June 2022

Maintenance Building Revised Design Report S4.55 Mod 1 Application

Figure 17 Rendered external elevations

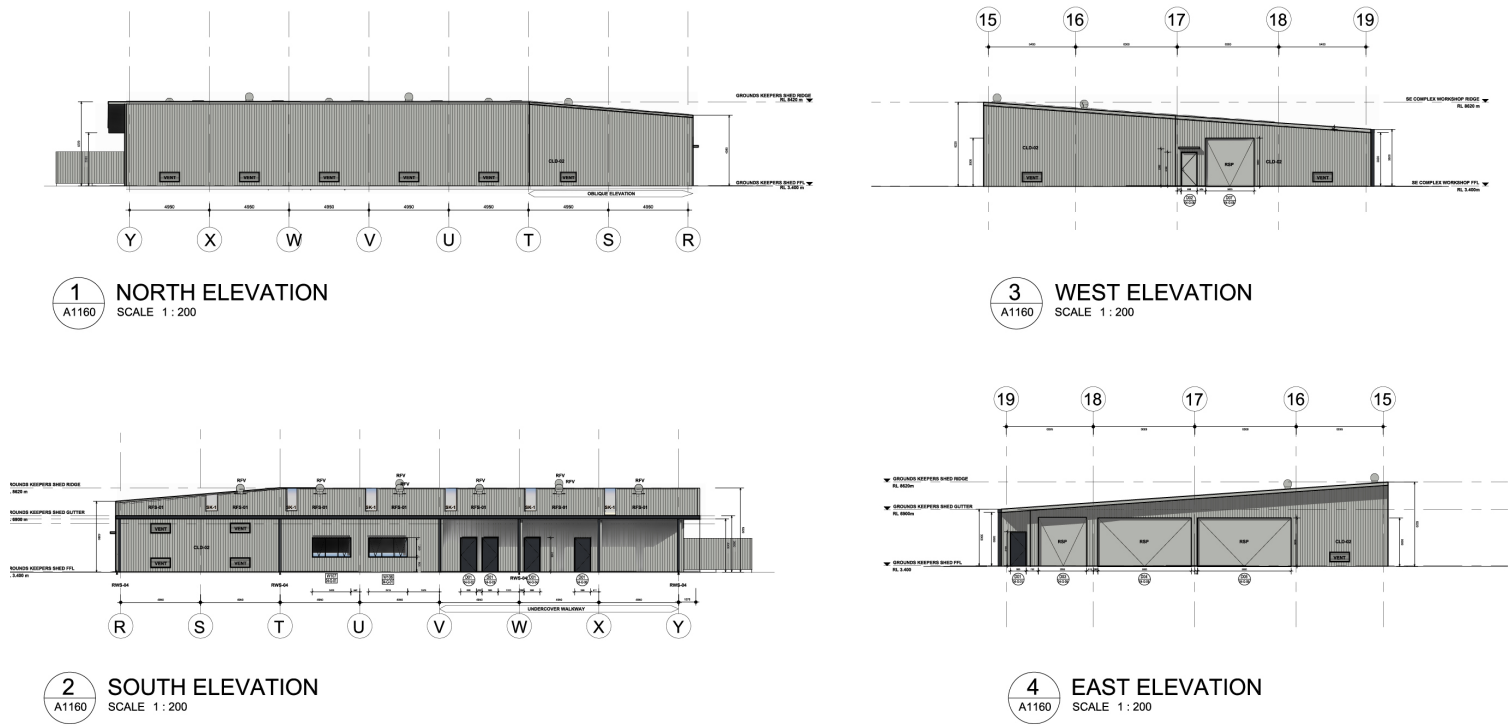
The proposed modified building is similar in materiality to the approved building. The approved building includes a metal deck roof and walls with a monument colour to match the dark charcoal of the main NSW Cricket Centre building. The proposed modified building is also clad in a metal deck roof and walls, however is now a lighter colour of shale grey which is present on the main NSW Cricket Centre building's roofs and external doors so as not to introduce an additional colour to the precinct's colour palette.(Figures 15 and 17)

The lighter colour of the new building also provides better internal amenity within the groundskeepers building as it reduces heat gain. This reduction in heat gain is also aided by the northern, eastern and western walls which are surrounded by groves of existing and proposed trees that give shade to the building. The building's roof now on show to people circulating past it to the south, now has skylights and roof vents breaking down and articulating this 5th elevation and again result in a better environmental outcome internally with the implementation of natural daylighting and passive ventilation.
